**LEXINGTON-FAYETTE URBAN COUNTY GOVERNMENT
CONTRACT CHANGE ORDER
Page 1 of 2**

Date:	April 10, 2017
Project:	Government Center Parking Garage Repair
Location:	200 East Main
Contract No.	034-2017
Original Contract Amt.	\$144,230.00
Cumulative Amount of Previous Change Orders	\$0.00
Percent Change - Previous Change Orders	0.00%
Total Contract Amount Prior to this Change Order	\$144,230.00
Change Order No.	1

JUSTIFICATION FOR CHANGE

CHANGE ORDER: 1

Material: **18 GA 304 SS**

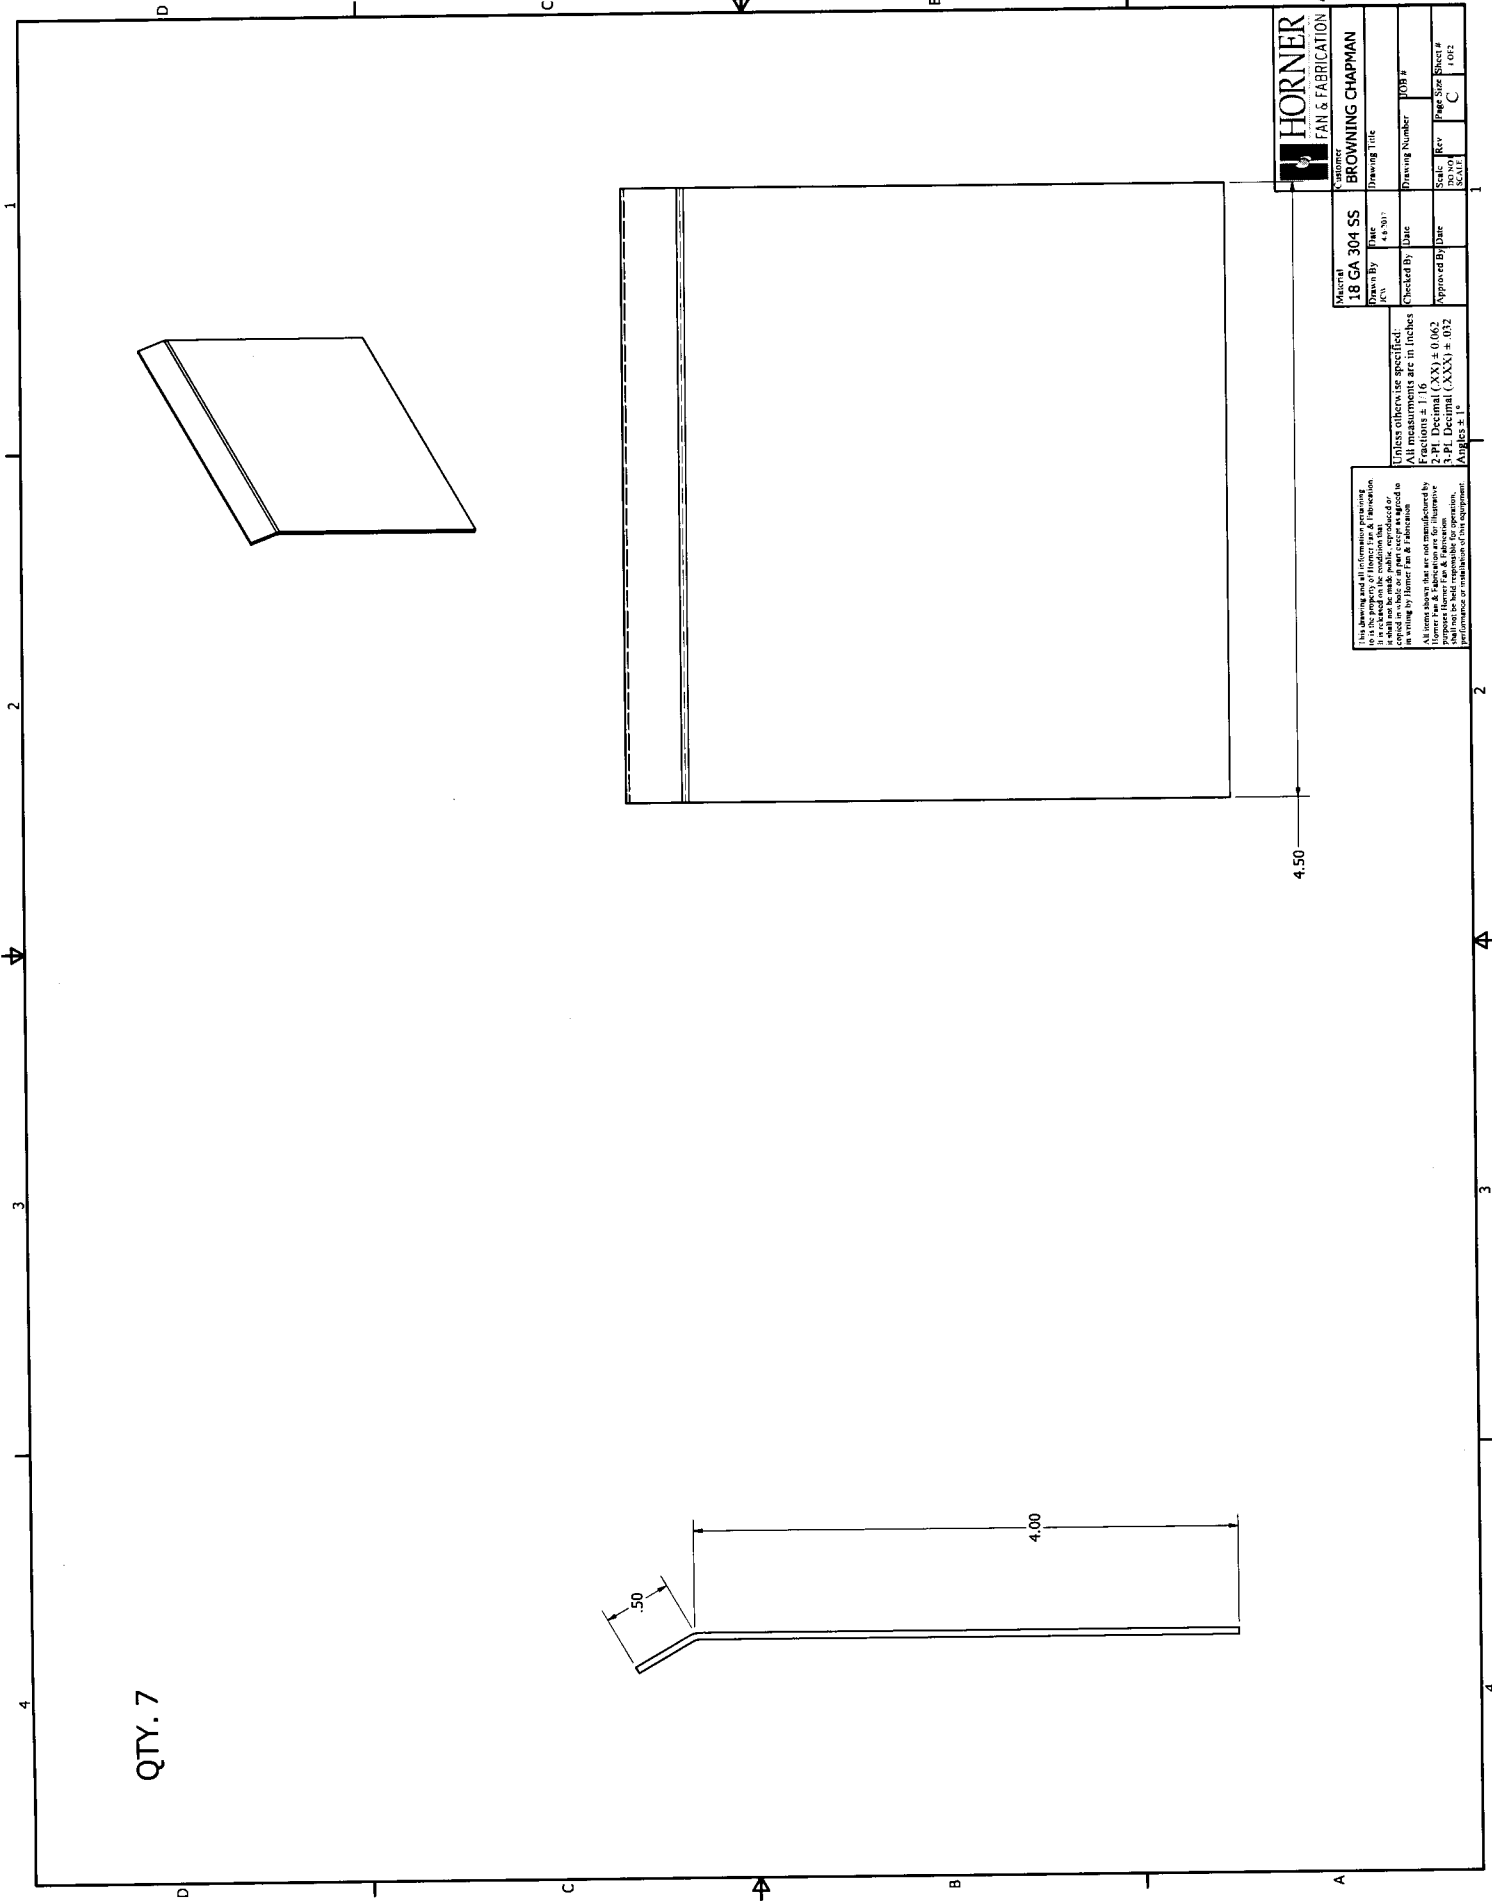
- o Remove brick and re-install existing brick
- o Replace lintel with new galv dipped lineal (Three sections)
- o Install brick ties, membrane and flashing per THP detail.

1. Shore sections as needed and block door with proper signage.
2. Remove sections of brick, cut lintel and remove section.
3. Install new lintel and anchor. Place stainless steel flashing over steel lintel seems. Apply Carlisle waterproofing over anchors and Lintel.
4. Place posi-ties and set brick. Tuckpoint brick and misc areas on each side of entry.

Material	3/8" MS	Part	44-501
Drawn By	JCV	Checked By	DATE
Scale	1:1	Approved By	DATE
Sheet	100	Rev	2.012
Scale	1:1	Page Size	J.012

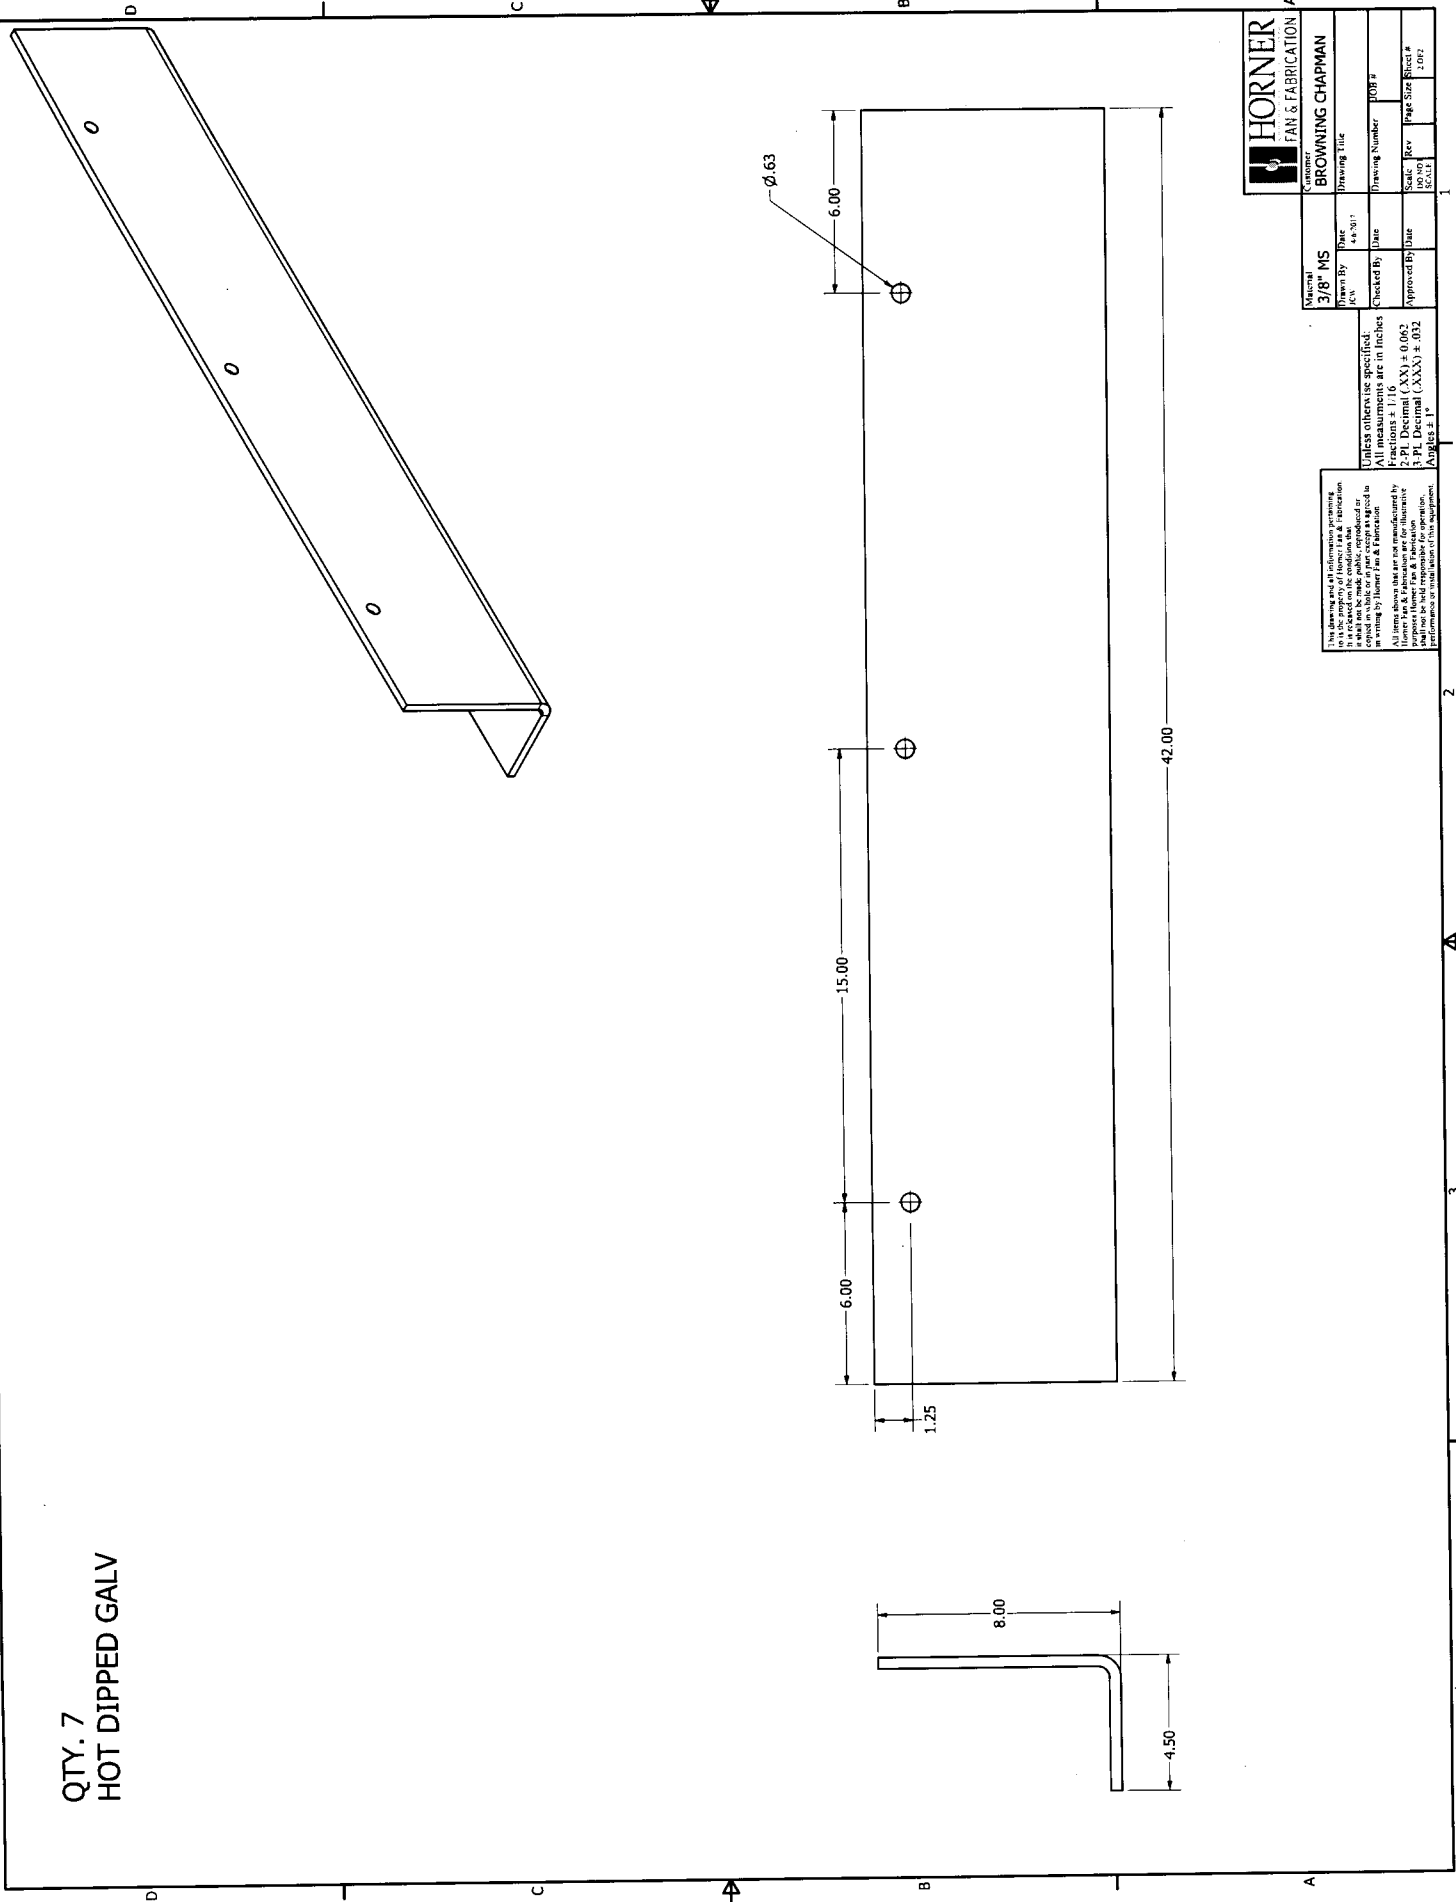
QTY. 7
HOT DIPPED GALV
